## Service Bulletin SB-11

**February 10, 2020**

### I. SUBJECT

This Mandatory Service Bulletin addresses the elevator trim system, specifically the cable to drive chain connection on some Cessna 208 series aircraft. The defect could result in a loss of continuity in the elevator trim control system resulting in loss of the pilot adjustability of elevator trim.

Figure 1 - Comparison of Trim Cable Terminal Assemblies

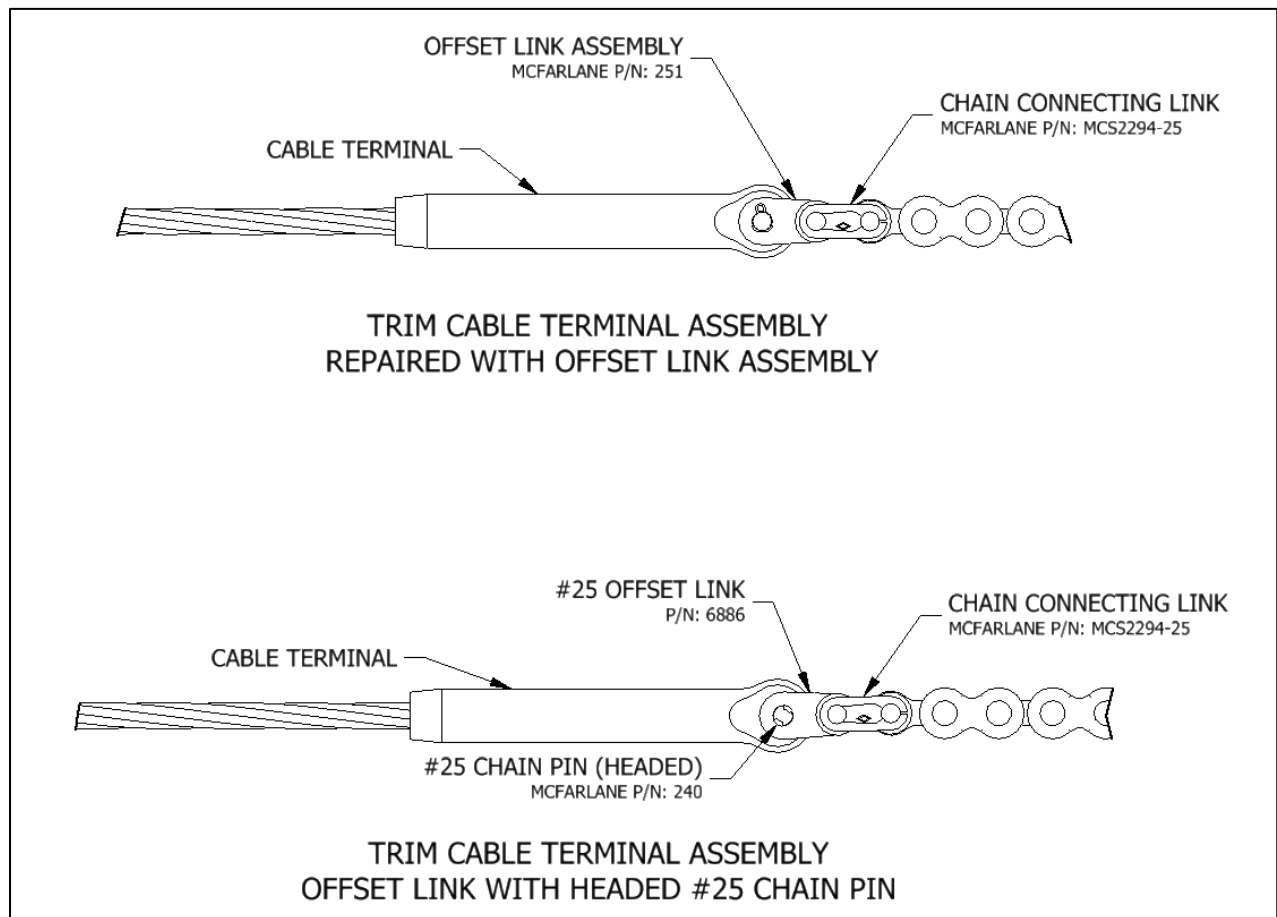
A possible defect in the chain pins that retain the offset chain connector links has been detected. These connector links and their riveted chain pins connect the interconnect cables to the #25 drive chains in the aircraft elevator trim system. The offset chain link is connected with a riveted chain pin to the trim cable terminal during manufacture of cable assemblies. Oversize holes in a specific batch of offset connector links have been found during recent production. The oversize connector holes could result in insufficient chain pin head size to properly retain the chain pin in the connector. This service bulletin affects a small group of trim cables released between May 6, 2019 and December 13, 2019.

The affected cable assemblies were released from McFarlane Aviation Products (McFarlane) between May 6<sup>th</sup>, 2019 and December 13<sup>th</sup>, 2019. Search the aircraft maintenance records for replacement of the elevator trim cable assemblies listed under Section IV. The affected cable assemblies have a riveted chain pin connecting the offset link to the cable terminal fitting. Note that only McFarlane cable assemblies use an offset link between the cable terminal and the chain connecting link. The original Cessna Aircraft Company cable assemblies does not use an offset link.

3. With rigging tension off the cable, locate the offset link and chain connecting link; see figure 1 for illustration and description of the connecting hardware. *NOTE: Only McFarlane trim cable assemblies utilize an offset link, and a chain pin connection, to connect to the connecting link.*

4. Disconnect cable by removing chain connecting link.
5. Remove headed clevis pin as follows:
  - a. Support the side of the offset link and the attached cable terminal with a bucking bar or other appropriately sized metal bar.

- b. Use a .090 pin punch to drive headed clevis pin out of offset link and discard pin (P/N: 240), and offset link (P/N: 6886).
6. Install new Offset Link Assembly as follows:

- a. Align offset link pin hole with cable terminal pin bore.
  - b. Insert clevis pin through both offset link and cable terminal.
  - c. Press and hold pin against offset link.

- d. Install cotter pin through end of clevis pin and bend around to secure.
  - e. Inspect the cotter pin for proper installation.
7. Install the new chain connecting link (P/N: MCS2294-25)
